**RESPONSES OF WINDHAM SOLAR, LLC
TO
CONNECTICUT SITING COUNCIL INTERROGATORIES - SET ONE**

On August 10th, 2020, the Connecticut Siting Council (“Council”) issued Interrogatories, Set One to Windham Solar, (“Petitioner”), relating to Petition No. 1359A. The Petitioner offers the following responses.

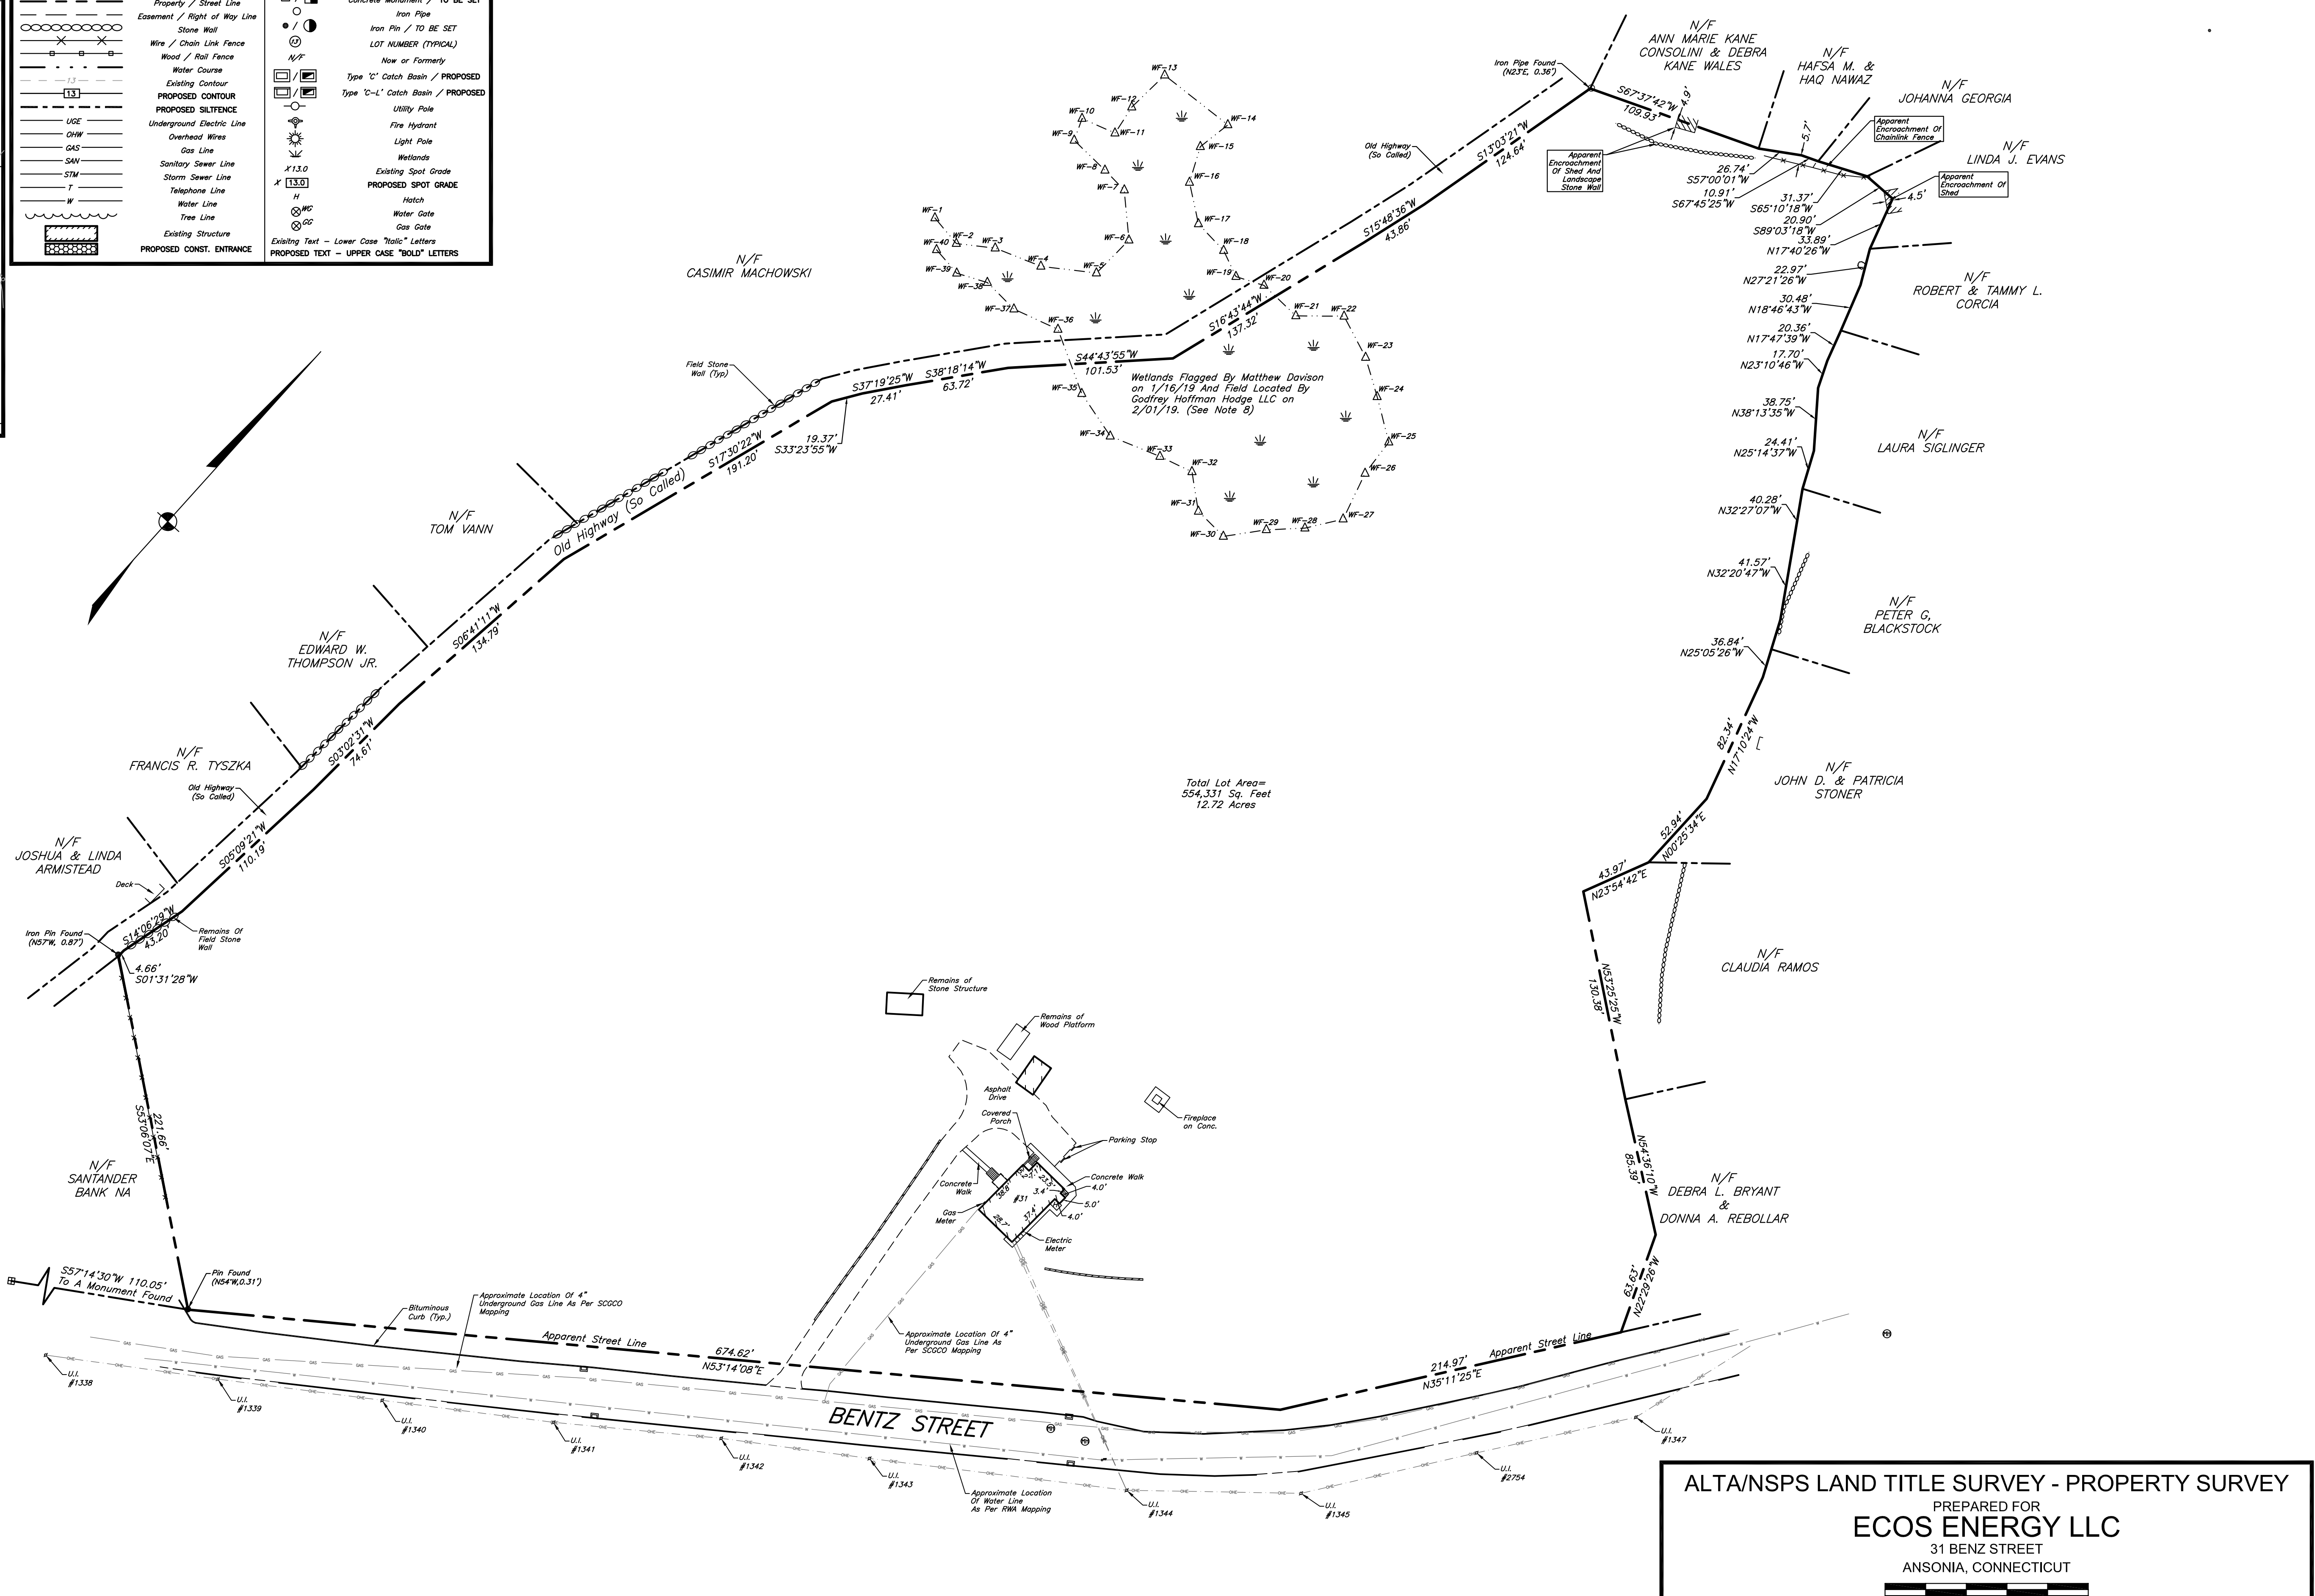
5. Petition p. 13 and Site Plan Sheet 3 list distances from the solar array to the residences on the east and west sides of the project. No similar information is given for the distances to the residences on the south side of the array, across Benz Street. Please revise the site plan to show this information.

Additionally, referring to p. 13, how many panels and rows would have to be removed to achieve a minimum distance of 100 feet from the solar array to the residences on Benz Street?

Distances to the residences south of Benz Street have been illustrated on the revised site plan documents. *Exhibit A – Sheet 3* The residences range from 153’ to 183’ to the solar array. No modules would have to be removed to maintain a minimum distance of 100 feet from the solar array to the residences.
